AusNet 2026 - 2031 Regulatory Proposal

REVIEW OF PROPOSED EXPENDITURE FOR ICT

Report prepared for:
**AUSTRALIAN ENERGY
REGULATOR (AER)**
August 2025

Figure 2.3: Sequence and interdependency of initiatives in AusNet's proposed Asset Management project

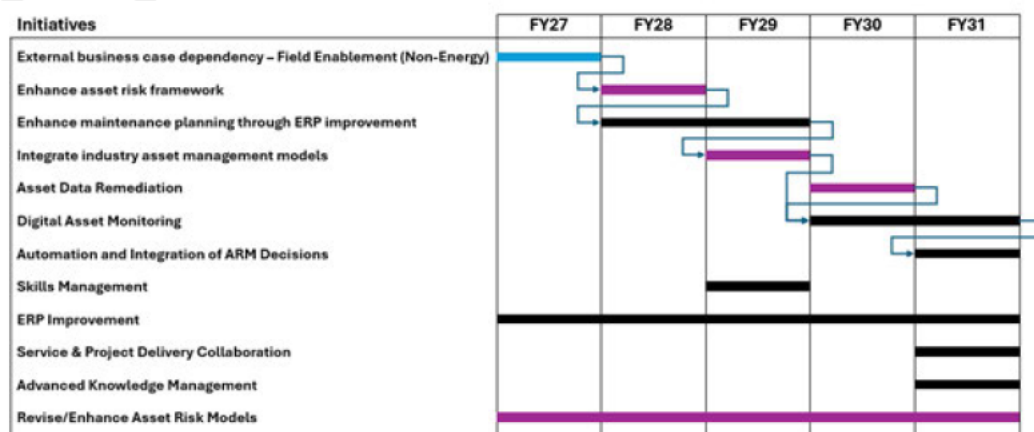
AusNet did not provide information that would enable consideration of the relative economic case for inclusion of the initiatives that it has proposed

59. We next sought to understand the extent to which AusNet had (or could) disaggregate benefits in its CBA, to align them with the initiatives and focus areas. It is not clear whether AusNet had previously sought to do so, since information in its business case provided no indication of it having reviewed the project from this perspective. Nevertheless, AusNet provided the following assessment in its response to our IR.

Figure 3.3: AusNet ICT (TAM applications), historical (actual) and forecast - \$m, real 2024²⁴

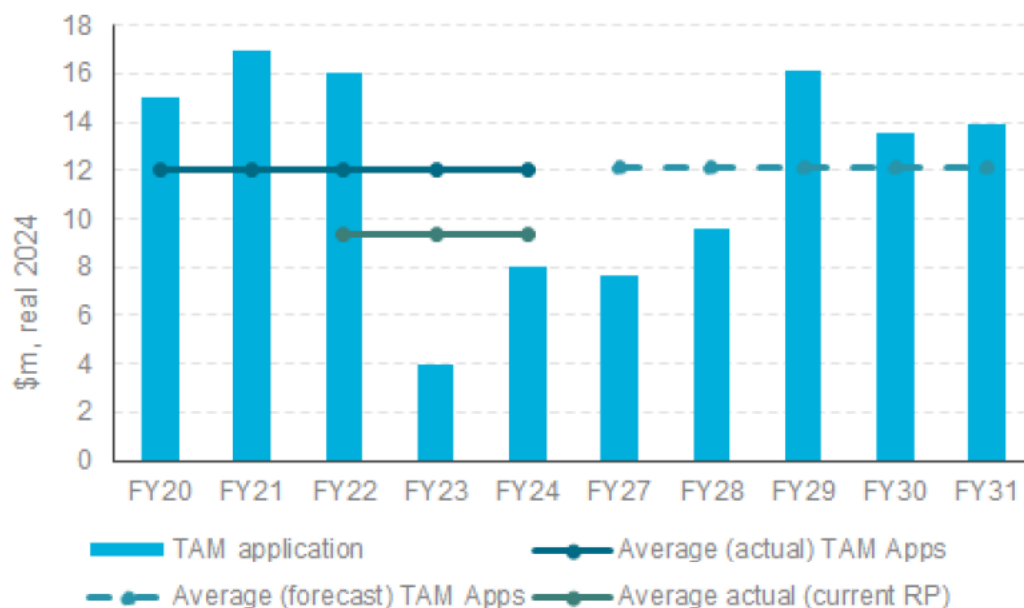
124. AusNet proposes \$15.7m of TAM applications recurrent expenditure to be incurred in 2031. This represents 23% of its proposed expenditure for the period. We consider it likely that AusNet will find opportunities to prudently defer some of these upgrades in which case they will not occur in the next regulatory period. While we would not prefer option 3 over option 2, we nevertheless consider that option 3 does provide some indication as to how AusNet might determine opportunities for deferral, and the impact that this would have on its forecast requirement.

Figure 3.4: AusNet ICT (TAM) infrastructure, historical (actual) and forecast - \$m, real 2024²⁹

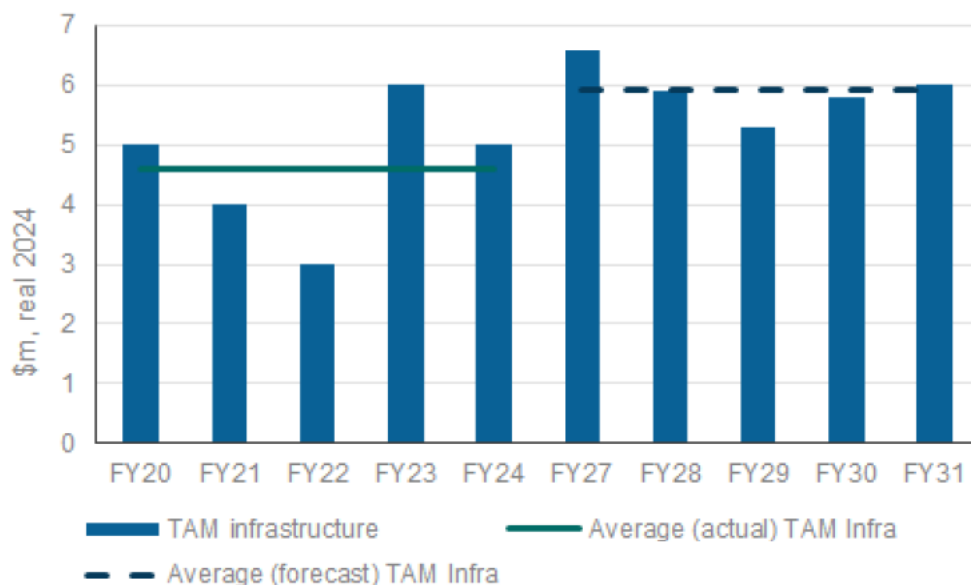
142. While AusNet's explanation suggests an expectation of a need for increased expenditure in the next period, this does not in itself validate the quantum of its proposal and we investigate other aspects of AusNet's proposal in our assessment below.

Figure 3.5: Project Benefit/cost ratios

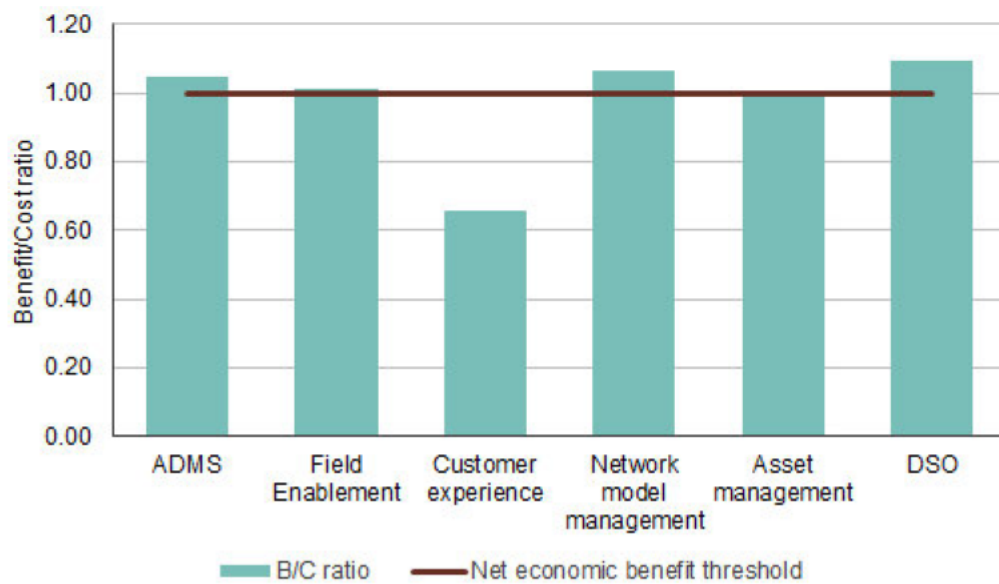
159. In Figure 3.5 we show the Benefit:Cost ratios for the non-recurrent projects that AusNet has proposed.
160. As can be seen here, one project has a negative NPV (B:C ratio<1.0) and for the remainder, the ratio is only marginally positive. This led us to consider, in assessing each project, the extent to which the project was realistically likely to provide a net benefit. It also led us to consider the extent to which the economic assessments may be burdened by the inclusion of low maturity elements of scope, that were adding to cost but without clear articulation and inclusion of sufficient economic benefits and whether, therefore, a project comprised only of more mature scope elements might provide a more compelling economic outcome.

Figure 3.7: Summary of customer satisfaction research

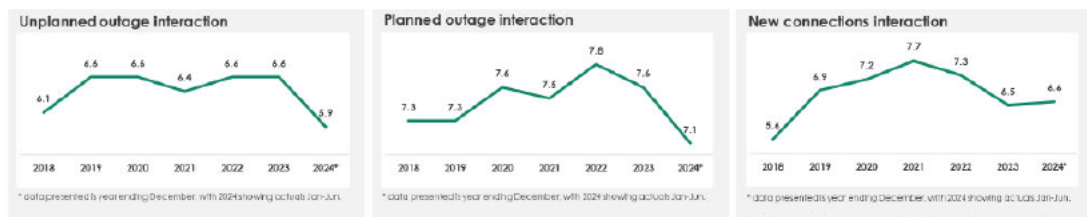
187. Despite the investments made in the current period, AusNet states that customer experience has deteriorated. AusNet provides information on three customer satisfaction metrics which we reproduce in Figure 3.7 as evidence of this claimed deterioration.

Figure 3.9: Customer experience business case benefits (\$m, NPV, real 2024)

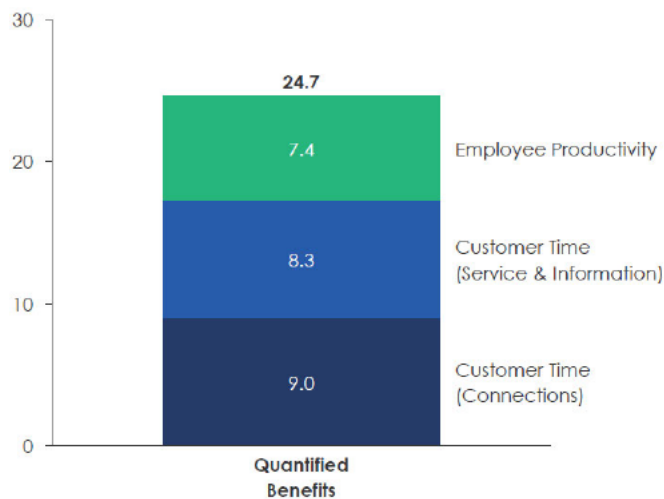
AusNet's CBA is negative

203. Non-recurrent projects that are driven by enhancements, are required to show a positive economic case.
204. In its business case, AusNet undertakes a CBA in which it values customers' time and employee productivity benefits, as shown in Figure 3.9.
